**NOTICE OF ADDENDUM
ADDENDUM NO. 1**

**CONTRACT NO. 7951
Capitol East District Parking Structure**

CONTRACT NO. 7951
Capitol East District Parking Structure

D5 ELEVATOR FOUNDATION PLAN
1/4" = 1'-0"

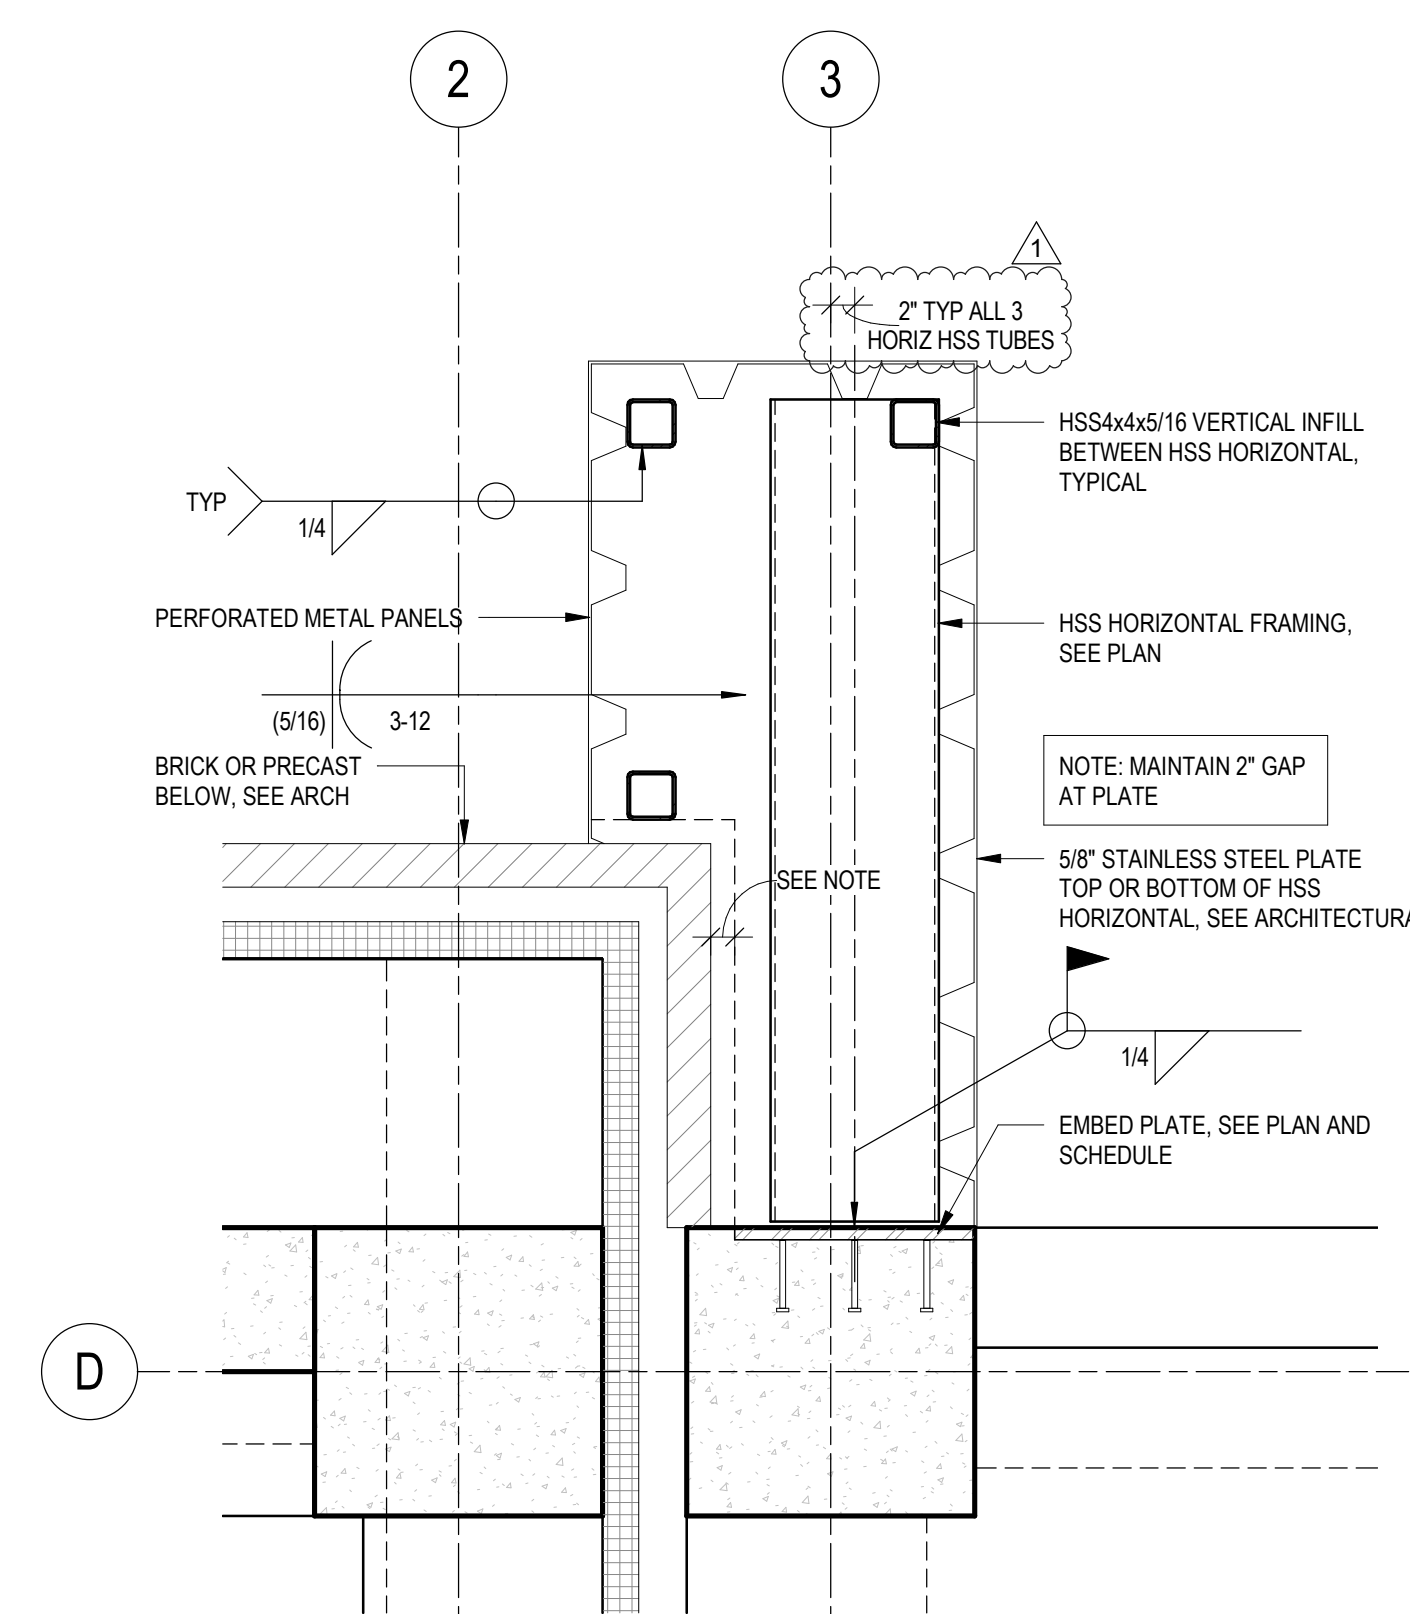
- xii. Add design load criteria to south east corner of garage.
- F. S-201 –Enlarged Plans (Reissued)
 - xiii. Add note to elevator foundation plan.
 - xiv. Add keynote to stair framing plan.
